RE: Permit Number NAN-2017-00912
Modification of Authorization under Nationwide Permit #38
Former North Water Street MGP Site
Central Hudson Gas & Electric Corp.
2 Dutchess Avenue
Poughkeepsie, New York 12601

REMEDATION SEQUENCE
AND CONTROLS
FORMER NORTH WATER STREET MGP
POUGHKEEPSIE, NY
FIGURE 1-A

For Agency Review Only
REMEDATION SEQUENCE
AND CONTROLS
FORMER NORTH WATER STREET MGP
POUGHKEEPSIE, NY
FIGURE 1-B

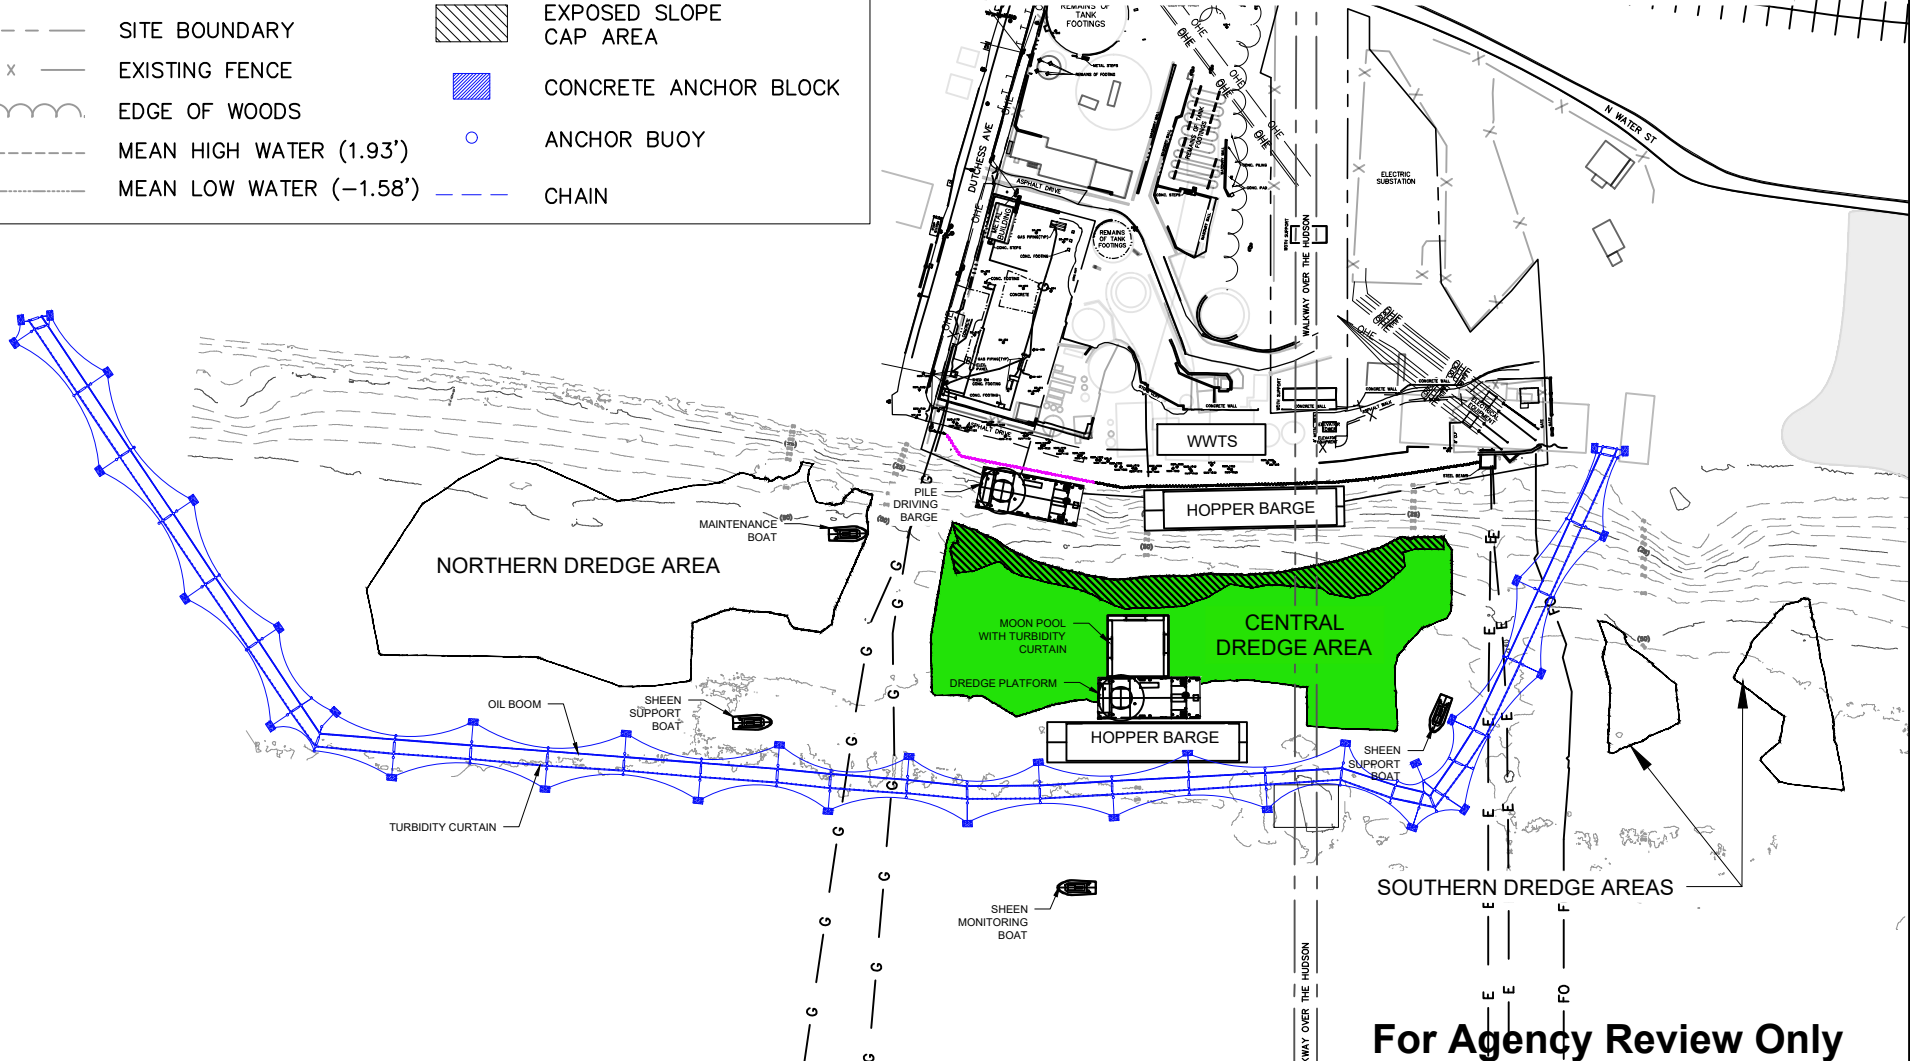
The main activity proposed for each August is the mobilization and installation of a double row perimeter curtain that will encase the northern and central dredge areas and all activities on the Hudson River slope adjacent to the Site. To prevent the double row perimeter oil boom and turbidity curtain from movement due to the river currents, prior to the first season of curtain deployment precast concrete anchors will be placed and attached to the turbidity curtain approximately every 100 feet (ft) along its length. The removable double-row perimeter curtain will then be moored to the anchors during remedial work and removed at the end of each season. The anchors will be approximately 12.5 ft by 8 ft by 6 ft in

size, weigh approximately 45 tons each and will be placed on alternating sides of the curtain alignment. The anchors will be removed after remedial activities have been completed. Figure 1-B provides a plan layout of the perimeter curtain and the associated blocks. It is anticipated that the mobilization and installation of the double row perimeter curtain will take between 3 to 6 weeks during the first season in 2019 (when the anchors are installed) and 2 to 4 weeks in subsequent seasons (when only the double row perimeter curtain itself is reinstalled prior to beginning work).

- **Season 2 – August 1, 2019 to January 31, 2020 (Figure 1-B):**
 1. Mobilization activities (as proposed above) will be performed in August.
 2. Following mobilization, but not prior to September 1, 2019, installation of barrier/bulkhead wall installation will be completed and dredging of the central area will be initiated.
 3. Following dredging of the entire central area, limited fill placement will be conducted in overlap between the River Slope cap placement and central dredge area.
 4. Commencement of dredging in the northern area, if time permits.
 5. Demobilization activities, including removal of oil boom and turbidity curtain.

For Agency Review Only
REMEDATION SEQUENCE
AND CONTROLS
FORMER NORTH WATER STREET MGP
POUGHKEEPSIE, NY
FIGURE 1-D

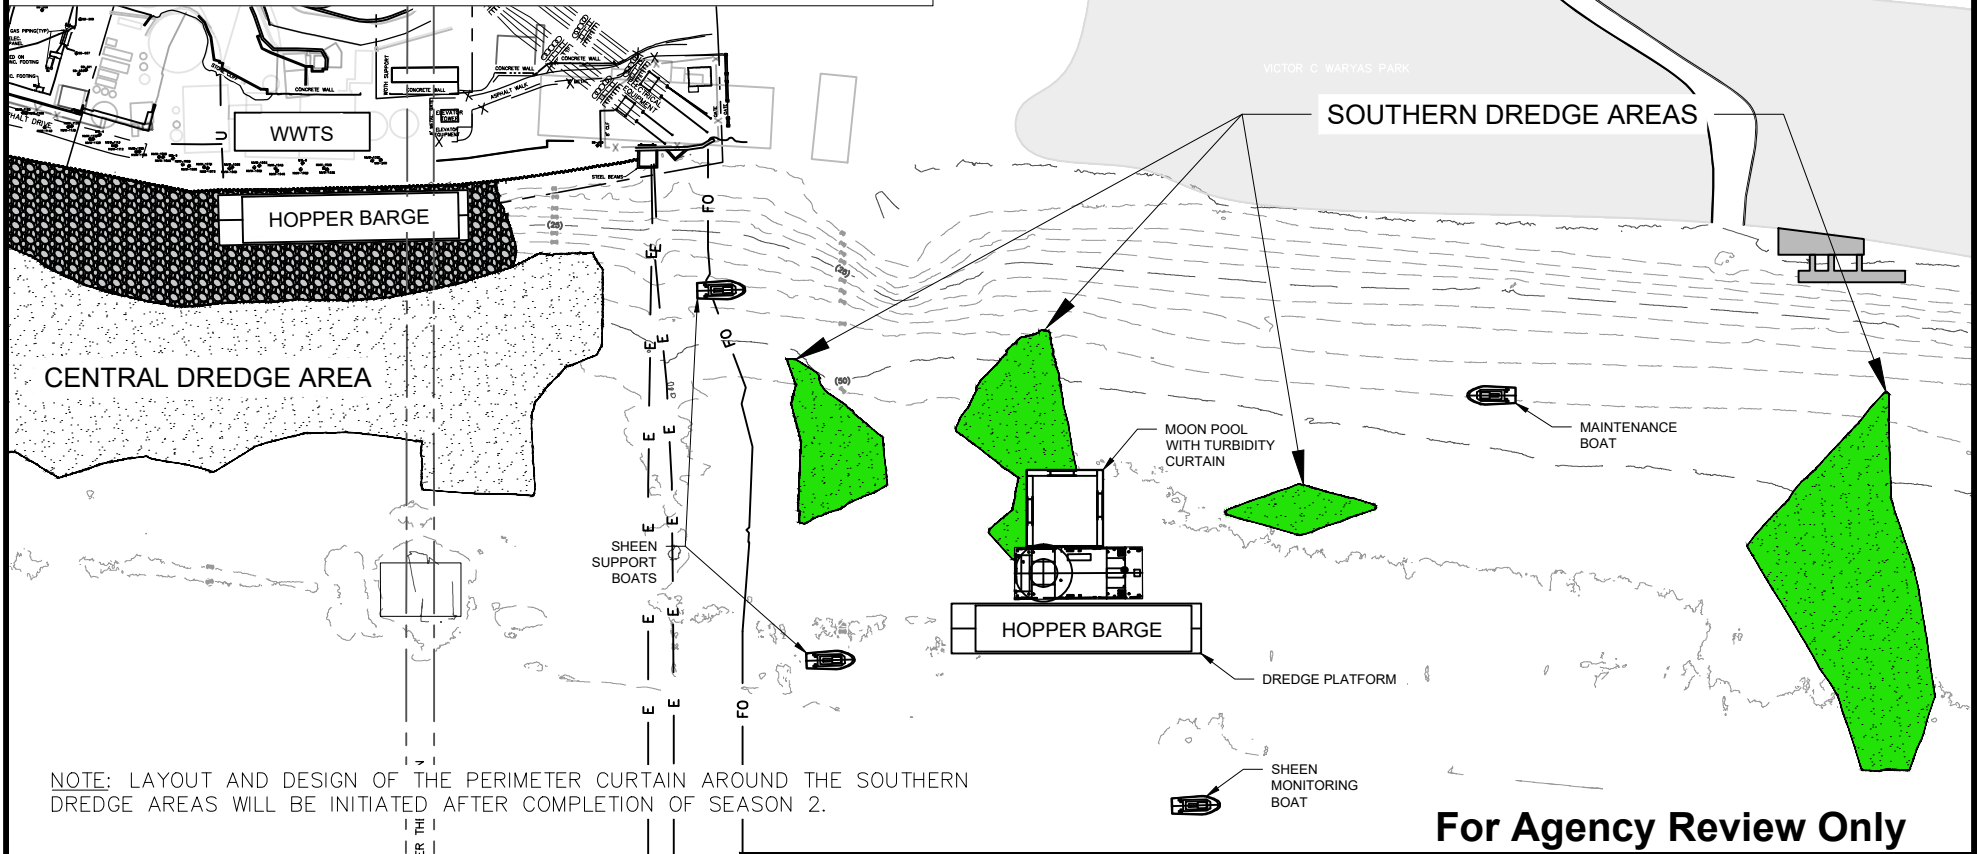
There is a line and note that states Perimeter Oil Boom and Turbidity Curtain. It is unclear what this is and how it will be anchored in this configuration. A detail should be added to explain the depth of curtain and method of anchoring. Season 4 dredging does not include the Perimeter Oil Boom and Turbidity Curtain; this should be added to the Season 4 dredging area.

There is a line and note that states *Perimeter Oil Boom and Turbidity Curtain*. It is unclear what this is and how it will be anchored in this configuration. A detail should be added to explain the depth of curtain and method of anchoring. Season 4 dredging does not include the *Perimeter Oil Boom and Turbidity Curtain*; this should be added to the Season 4 dredging area.

NOTE: LAYOUT AND DESIGN OF THE PERIMETER CURTAIN AROUND THE SOUTHERN DREDGE AREAS WILL BE INITIATED AFTER COMPLETION OF SEASON 2.

Based on the current anticipated construction schedule, Season 4 dredging will take place in the southern dredge area only. Consistent with the approved Remedial Design/Remedial Action Work Plan, this dredging will take place within a containment cell "moon pool" that will be enclosed with a turbidity curtain. The containment cell is the primary control for turbidity and sheens. Localized oil booms will be installed outside of the moon pool and around each southern dredge area during the dredging activity. Additional controls will include the use of support boats to monitor sheen. A second turbidity curtain (in the form of a perimeter curtain)

is not feasible around the southern dredge area due to the following:

- Installing a perimeter curtain around the entire southern dredge area will result in inclusion of the area where the Fall Kill enters the Hudson River.
- A perimeter curtain around the southern area will include and therefore impact the boat launch area within the Victor C. Waryas Park and the boat slips adjacent to the Poughkeepsie Ice House restaurant. Both would require leaving a portion of the curtain open to allow boat traffic in and out of the perimeter curtain creating an ineffective mitigative control.
- The southern dredge area comprises multiple distinct dredge areas with large non-dredge areas in between requiring a perimeter curtain that will need to cover a very large area.
